Staff Report

To: Planning Commission

From: Dan Handel, AICP, Planner

Item: DR 23-06, RSS 23-01, SA 23-03, & VAR 23-03 "3rd Street Quadplex" at 1123 & 1125 N. 3rd Street

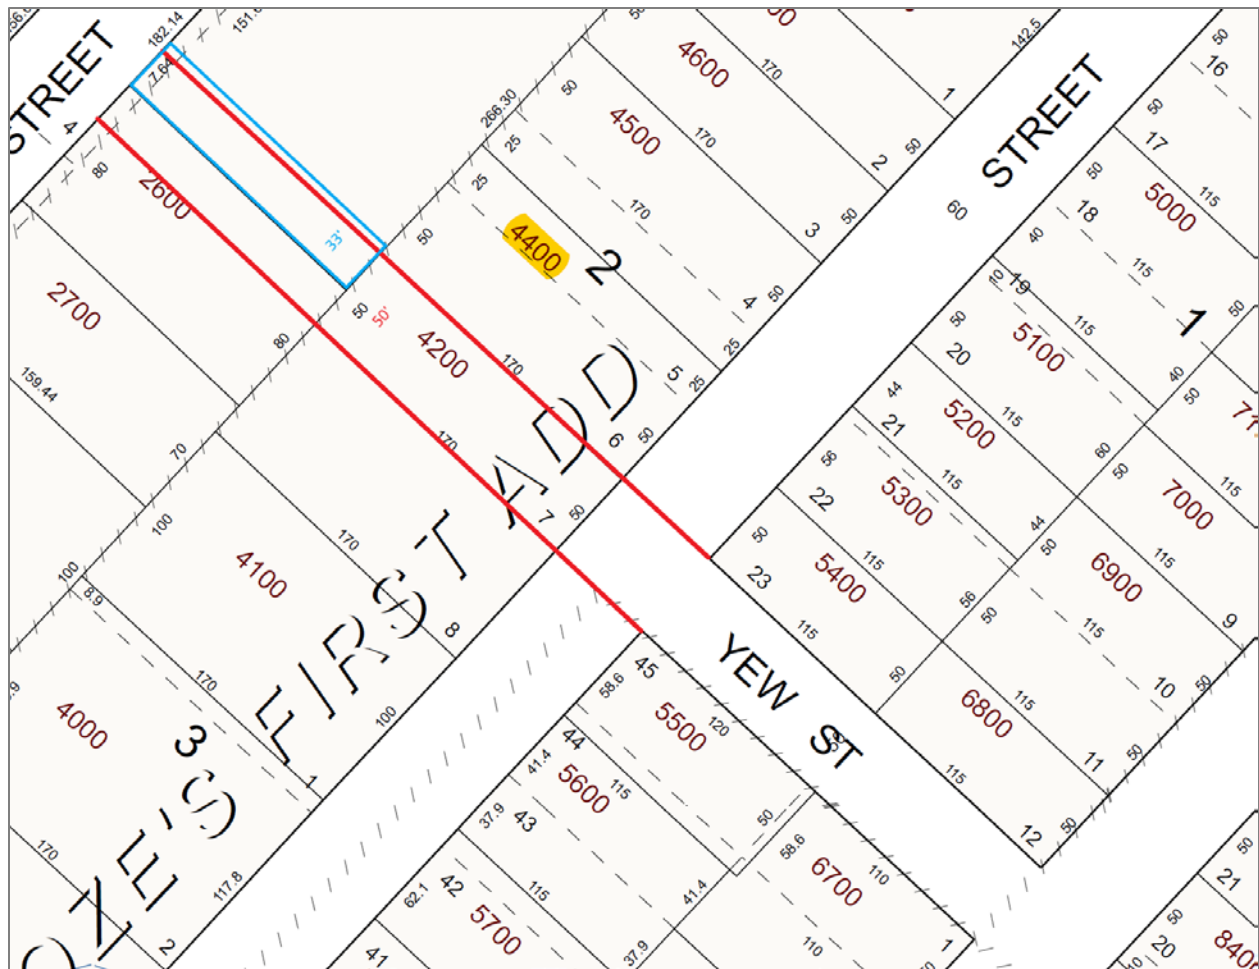
The existing structure on the property is situated within 5 feet of the southerly property line. Dedication of a 5-foot public utility easement would encompass part of the existing structure. It is proposed, therefore, that the applicant record a restrictive covenant that would grant the easement in the event that the existing structure is ever removed from the property. The proposed development is situated outside of the public utility easement corridor and would comply with the restrictive covenant.

The applicant submitted a Street Adjustment application with a request to modify the applicable street cross-section for the future Yew Street extension that is illustrated on TSP Figure 6 "Local Street Connectivity Plan". The default cross-section for local streets is Figure 3.01G. The applicant is requesting to instead apply a 50-foot right-of-way cross-section such as Figure 3.01K or Figure 3.01L.

SITE PLAN

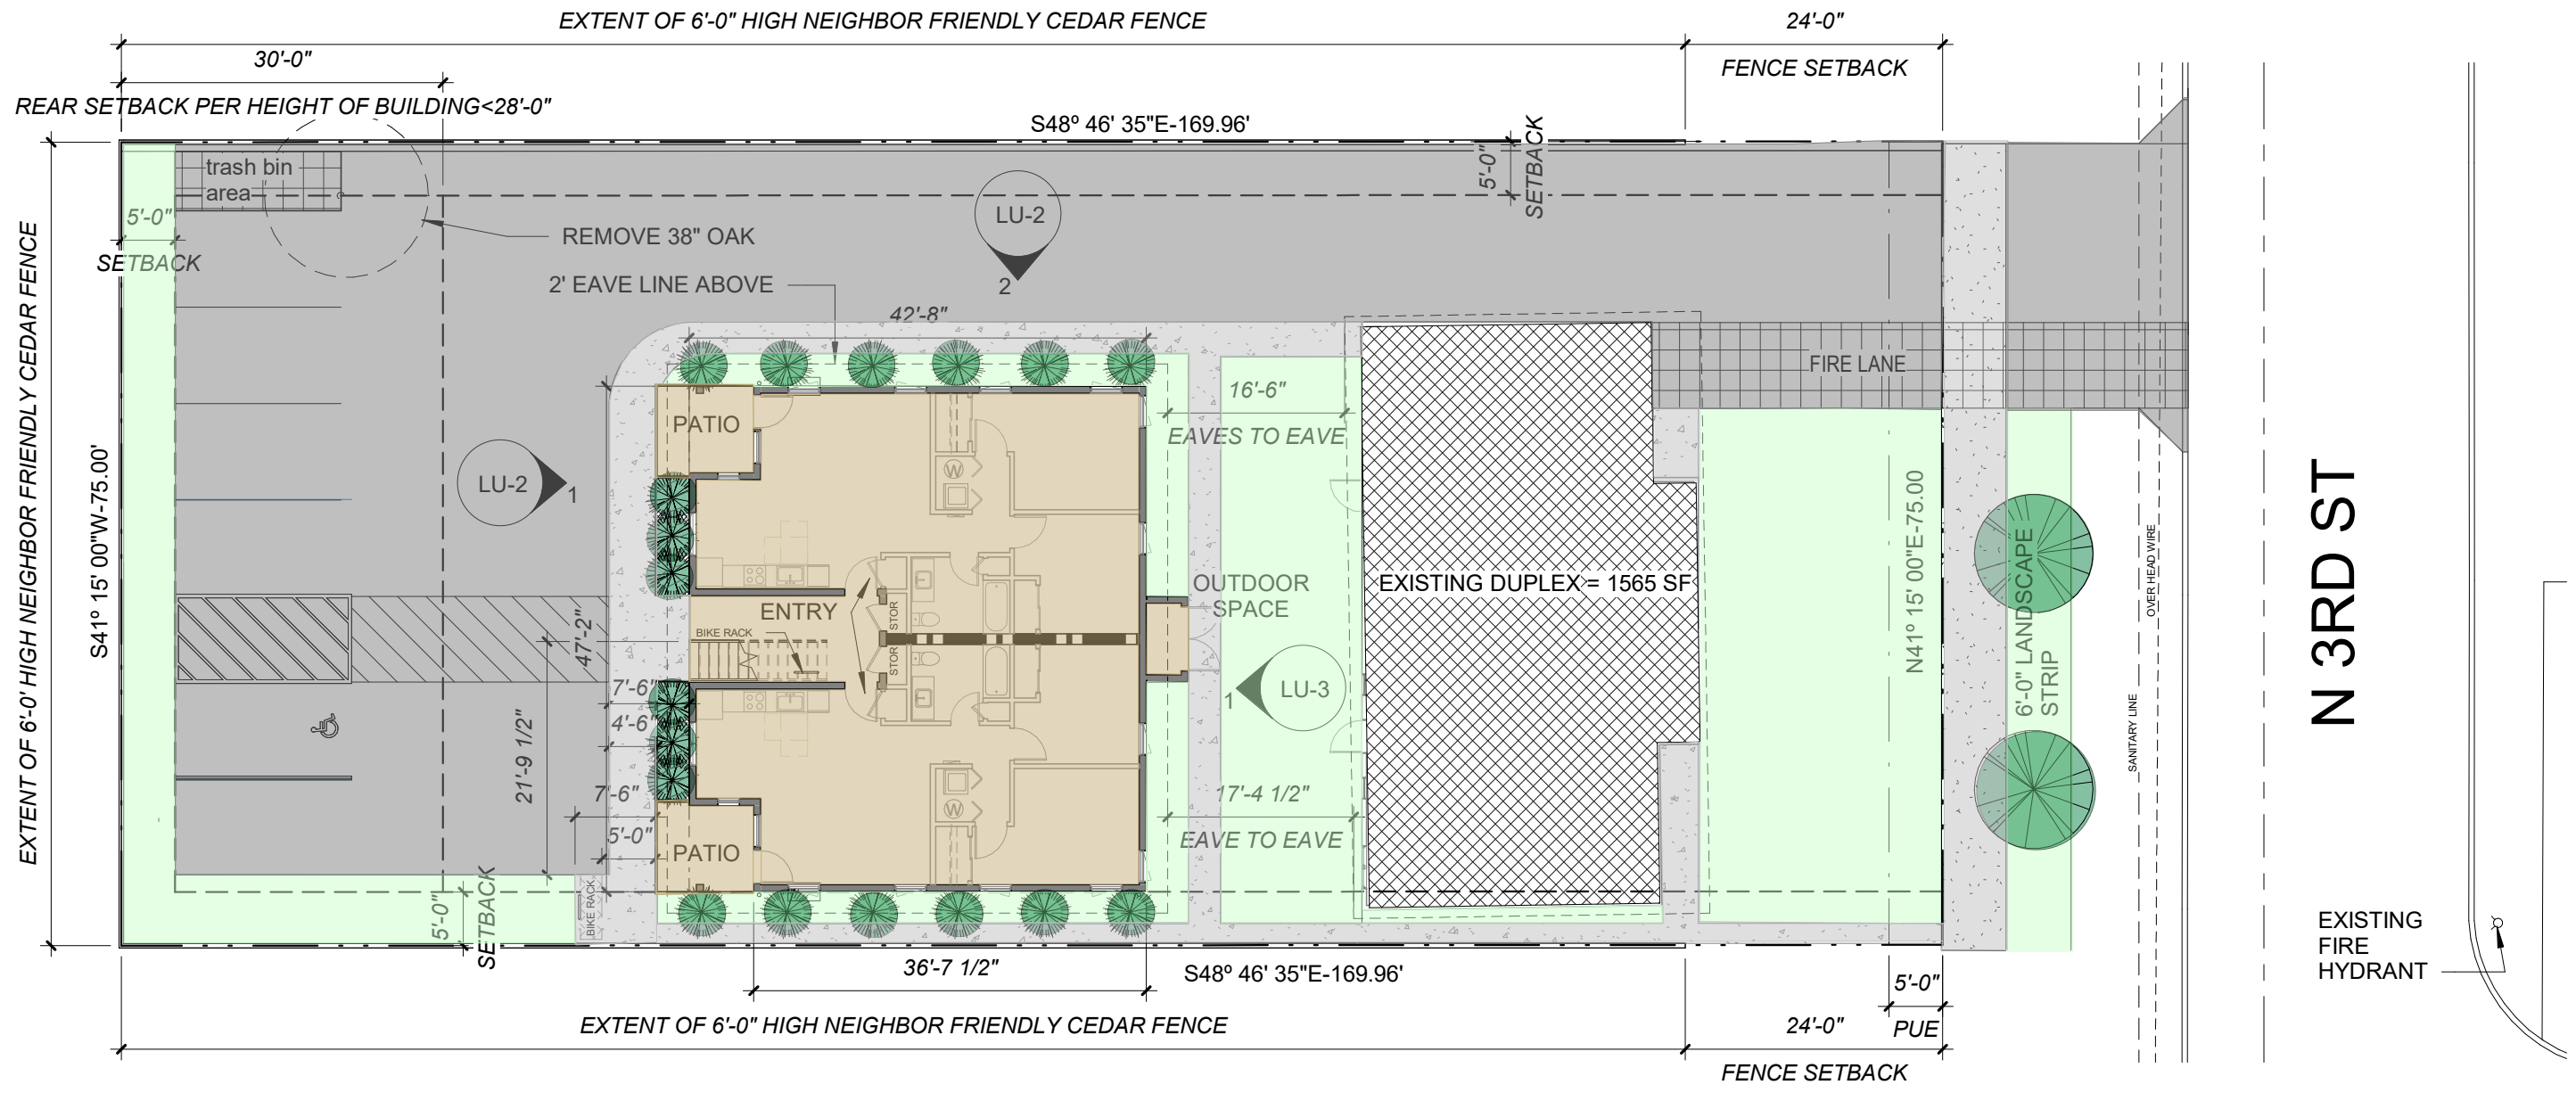
Site plans illustrate and note a 6-foot-tall cedar fence around the site. Because fences are reviewed separately from a Design Review, staff adds *Condition of Approval 3* to obtain a Fence Permit for this fence.

Site plans illustrate a 2-foot concrete walkway along the southwest property line connecting the proposed quadplex to the proposed sidewalk within N. 3rd Street right-of-way. Similarly, the existing duplex is connected to the proposed sidewalk via the driveway, through an 8-foot wide striped area.

Regarding bicycle parking, plans illustrate a bike rack adjacent to the parking lot and an additional stall underneath the staircase in the exterior stairwell.
